J2126A-09

S E R V I C E N O T E

Agilent J2126A Transmission Test Set

**Replacement of the 2.5Gb/s optics module from a 4-port to a 3-port variant
requires the additional selection of a suitable replacement Top Panel.**

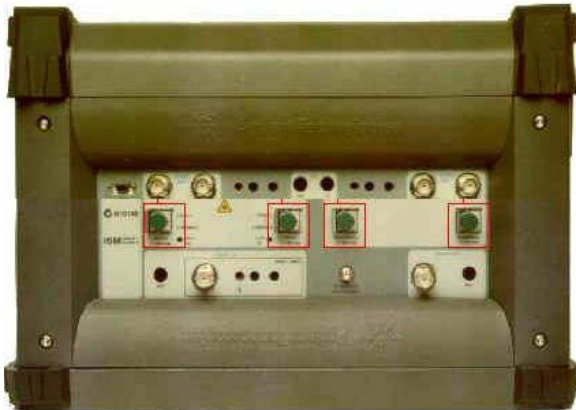
Older 2.5Gb/s optics modules have four optics ports. Support material has now run out such that these modules are no longer available. The module itself has been replaced by a newer three port variant which has a single multi-rate optical receiver (MRO).

When replacing the 4-port module with a 3-port module, there will be a “spare” hole remaining in the original Top Panel of the instrument.

When ordering a new 2.5Gb/s module, you must also order a new **Top Panel** as shown in the table below.
